Response to Reviewer #3 Comments

WRF-MLGR v2.0 / EGUsphere Green-Roof Manuscript

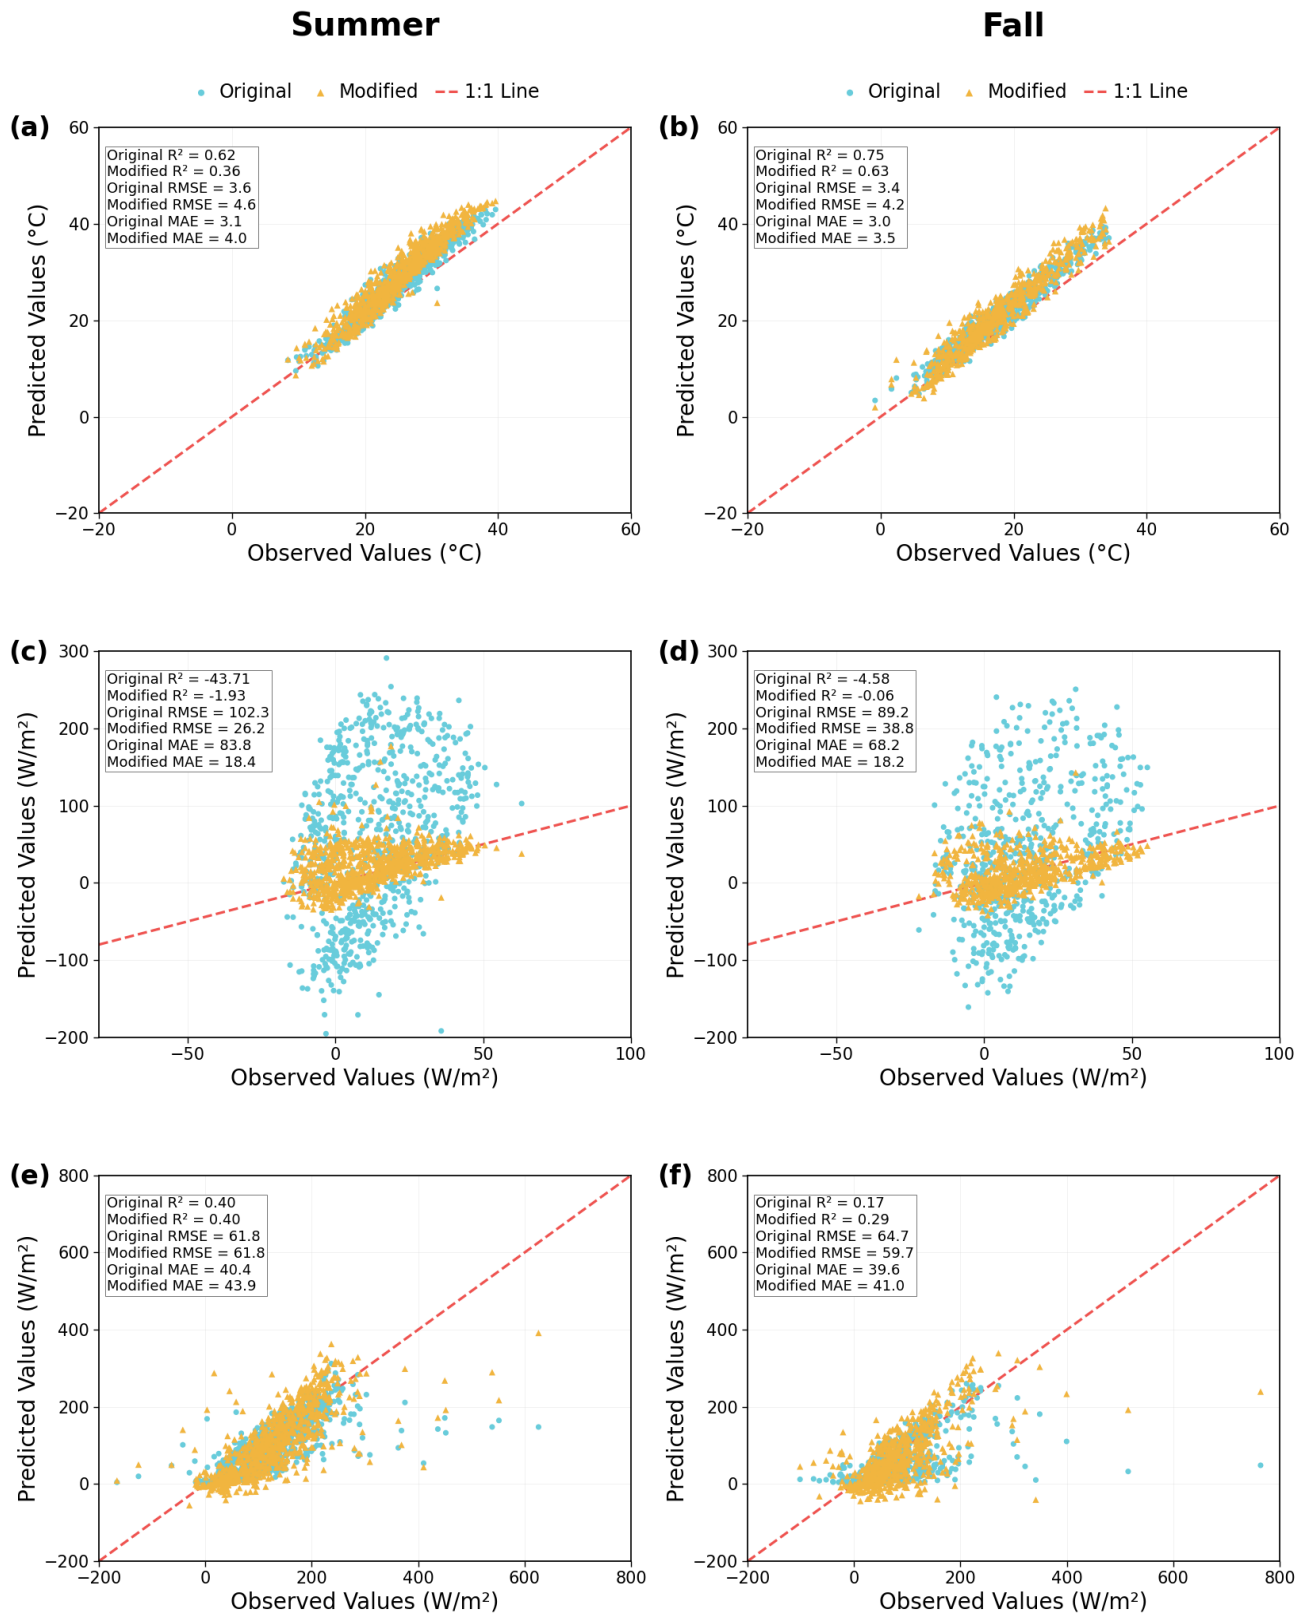
Reviewer comment: Please verify the statistical calculations in Table 1. Modified and Original RMSE for Q_E for the Fall is showing 316.2 and 369.7 corresponding to the MAE values. It is anomalously high in multiple places, while the scatter plots show something else. Please check this.

Reviewer comment: How can R^2 be negative in Figure 1 (c,d)? Please define R^2 , if it is the squared of the correlation coefficient it cannot be negative.

Reviewer comment: Figure 1: Scatter plot instead of plotting summer and fall images together. Considering plotting original and modified methods for summer in the left column and fall in the right column.

Reviewer comment: In some figures (Fig 2 for example), the tick sizes of the figure are small, thumb rule should be that the font sizes in the figures would be approximately same as the text size in the manuscript.

Reviewer comment: Perhaps include the statistical metrics in Figure 1, which would make it easier for the reader to compare the values directly. Mention these metrics under R2.

Reviewer comment: Instead of just colours, please use different markers (circles, squares or open circles) to denote summer and fall. Considering the low quality images it is really difficult to differentiate between different points.

Thank you very much for identifying this issue. We agree that the Q_E statistics in the original submission were inconsistent, and the reviewer's comment prompted us to audit the complete Q_E evaluation workflow.

During this re-check, we found two separate data selection mistakes. For the Q_E scatter plot, we inadvertently used an observational Q_E file that had been shared within our group for a separate dry period model test, rather than the final observational series used for this manuscript. For Table 1, we used a Q_E observational series before the final quality control/noise filtering step. These two mistakes explain why the scatter plot and Table 1 did not agree and why the fall Q_E RMSE values were unrealistically large.

We corrected both problems and regenerated Table 1 and Fig. 2 using the same quality-controlled hourly Q_E observational dataset. We also rechecked the affected calculations and revised the text so that it reflects the corrected results. The corrected results show that the original and modified models have similar overall Q_E performance in summer, while the modified model has a lower RMSE and higher R^2 in fall.

Thank you for pointing this out. The R^2 used in our scatter plots is not the squared Pearson correlation coefficient. We use the residual-based coefficient of determination, $R^2 = 1 - \Sigma(M_i - O_i)^2 / \Sigma(O_i - \bar{O})^2$. With this definition, R^2 can be negative when the model error is larger than the error obtained by simply using the observed mean as the predictor. We have now defined this explicitly in the Methods so that the negative values in the Q_G panels are clear.

Thank you. We reorganized the scatter plots as suggested. Summer is now shown in the left column and fall in the right column, and the original and modified model results are plotted together within each seasonal panel. We also use different marker shapes in addition to colors: circles for the original model and triangles for the modified model. This makes direct comparison much easier.

The reorganized scatter plot is now Fig. 2 because a new model schematic was added as Fig. 1. The revised Fig. 2 caption is on page 13, lines 335–339. The revised Fig. 2 is reproduced above under Reviewer Comment 1.

Thank you for the suggestion. We added the main statistical metrics directly to each scatter-plot panel. R^2 , RMSE, and MAE are now shown within each panel so that the original and modified model performance can be compared without moving back and forth between the figure and Table 1.

Thank you. We revised the scatter plot so that the comparison does not depend on color alone. Summer and fall are separated into the left and right columns, respectively, and the two model configurations use different marker shapes: circles for the original model and triangles for the modified model. This improves readability and makes the figure easier to interpret when colors are difficult to distinguish.

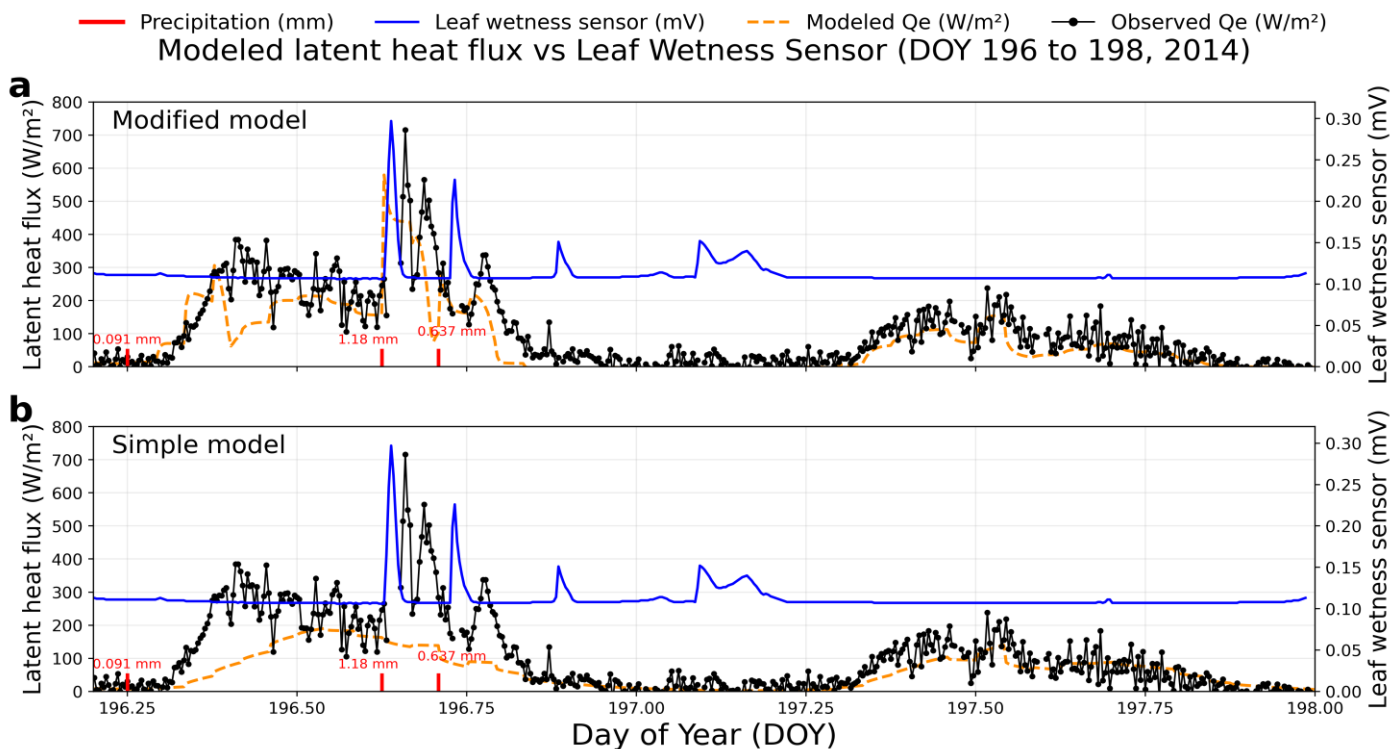
Reviewer comment: Figure 4, why is the observed Q_E not added in this figure? Please add that and discuss the implications.

Thank you for this suggestion. We agree that the observed Q_E should be shown directly. After the addition and renumbering of figures, the event scale figure referred to by the reviewer is now Fig. 5. We added the lysimeter-derived observed Q_E as a black line with markers in both panels and expanded the text to discuss the comparison.

“The lysimeter-derived observed Q_E also increases rapidly following rainfall and shows close temporal agreement with the modeled response, with only a small difference in the timing of the peak. In fact, observed Q_E is derived from changes in lysimeter mass over each measurement interval, which can contribute to small differences in the apparent timing of the responses.”

Figure S4. Combined summer 2014 time series of observations, the original WRF multi-layer green-roof model, and the modified WRF-MLGR v2.0 model. The same three series are shown together to allow direct comparison of timing and peaks.

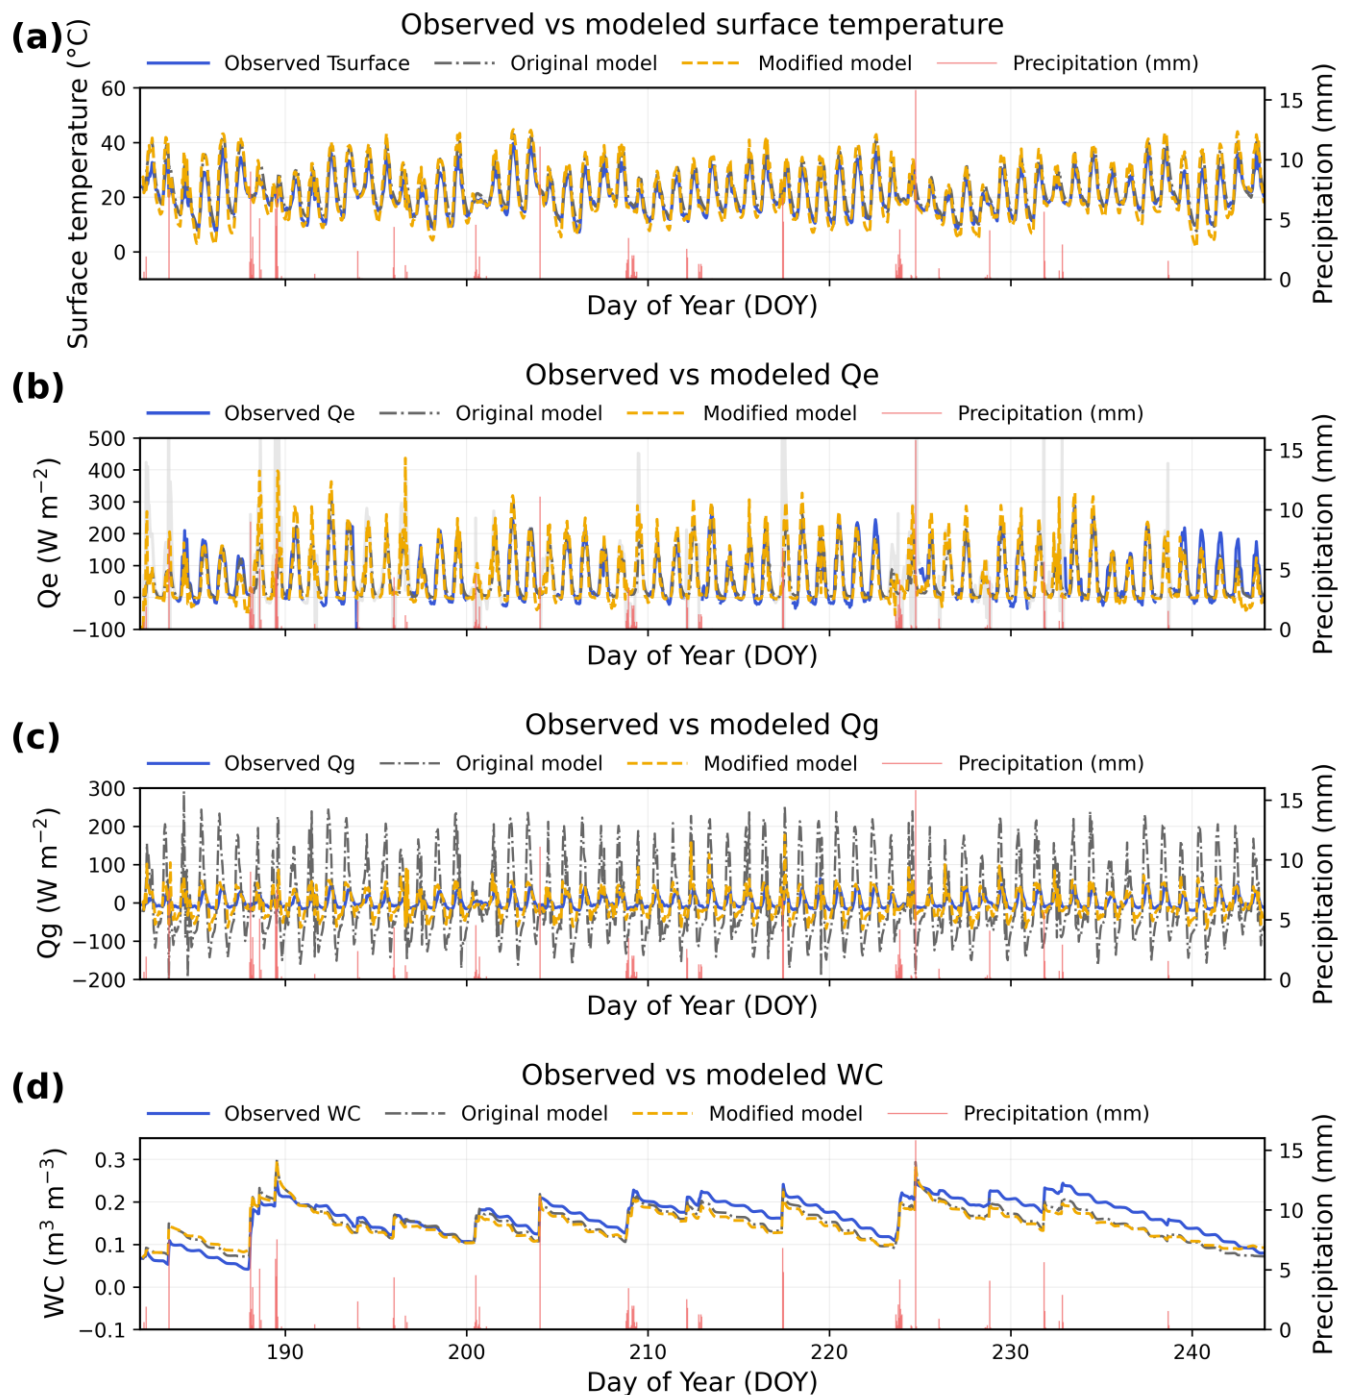
Reviewer comment: Line 245: Discussion about amplitude and timing and peak would require referring to actual time series of the figures rather than the scatter plots. I suggest presenting time series first and then present the scatter plot i.e. make Figure 2 as Figure 1. Also Figure 2 and Figure 3 could simply be merged by using different line styles. 3 lines in a single plot is not really a lot. This would make it easier for the reader to easily compare the old and the new method than scrolling down to see if there is a mismatch in the timing of the amplitude etc.

Reviewer comment: Line 270--275: Comparing the timing and peaks of different models would require that they be plotted in the same figure.

Thank you. We agree that direct comparison of timing and peaks is clearest when the model versions can be viewed together. We therefore prepared a combined summer time-series figure with observations, the original model, and the modified model overlaid in the same panels. Because the lines overlap strongly for several variables, placing this combined figure in the main text reduced readability. We retained the clearer separate time series as Figs. 3 and 4 and added the combined comparison as Fig. S4, with an explicit reference in the main text. This allows readers to compare the model timing directly without making the main figures difficult to read.

“For direct visual comparison of the timing and magnitude of the original and modified model responses, the corresponding time series are overlaid in Fig. S4 of the Supplement.”
